STAFF REPORT: MAY 10, 2023 MEETING

APPLICATION NUMBER: 23-8328

ADDRESS: 7938 E LAFAYETTE

SCOPE: ERECT GARAGE

Applicant site plan. E Lafayette is denoted by the thick line at the top of the plan.

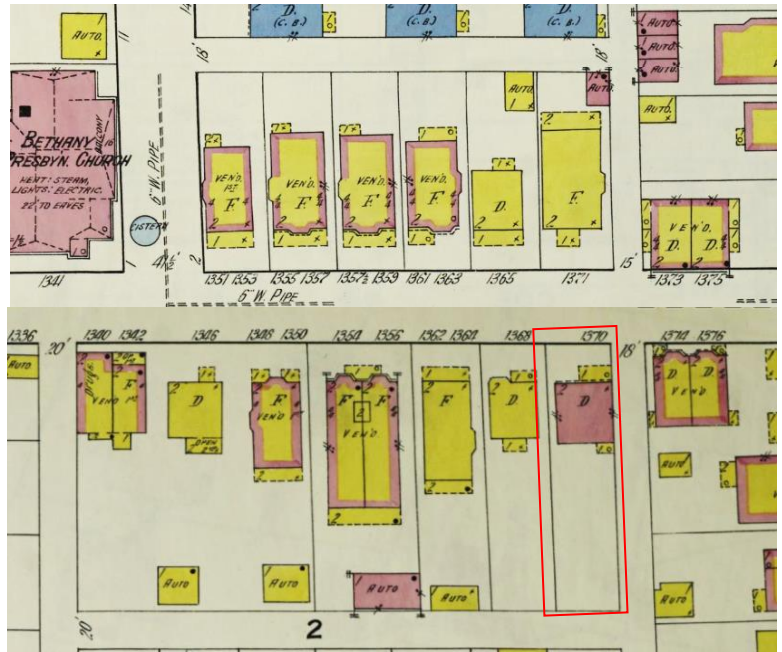
The applicant mentioned the garage will extend slightly inside of the rear wall of the existing chain link fence that encloses about half of the rear yard. The fence will then be reinstalled at the same location on either side of the garage. The fence is currently hard to see due to the overgrowth of the lot – the gate is the most visible element in this photo.

- Vinyl siding with a raised grain pattern was selected as the exterior wall covering. For new accessory structures to historic properties, mostly out of view, staff has consistently recommended against the use of vinyl siding in favor of siding manufactured from more traditional materials.

- Wood or cementitious siding will be selected for the exterior walls. Paint color will be submitted for staff review.
- Catalog cuts confirming the design, material, and finish color for the overhead and pedestrian doors will be submitted for staff review.
- Drawings will be amended as needed prior to submitting the permit application to BSEED.
